## CERTIFICATE OF APPROPRIATENESS

**Property:** 1634 Columbia Street, lot 22, block 113, Houston Heights Subdivision. The property includes a Non-Contributing residence situated on a 4,224 square foot (32' x 132') interior lot.

**Proposal:** Alteration – Replace front second floor balcony and first floor stairs.

**WEST ELEVATION – FRONT FACING COLUMBIA STREET**

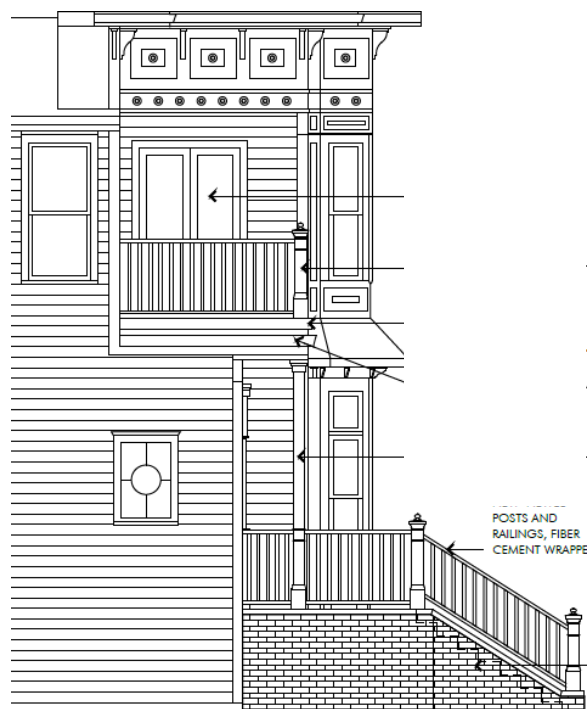
**Front Elevation:** Replace the existing wood 12' 9" deep by 4' 2" tall front porch stoop with a 13' 7" deep by 4' 2" tall  
**(West)** brick stoop. Replace the existing wood newel and hand railings with new cementitious material.  
Extend the existing second floor balcony by 1' towards the front property line. The added balcony space will be supported by a new wood support column. The balcony's existing wood hand railings and posts will be replaced with matching cementitious material.
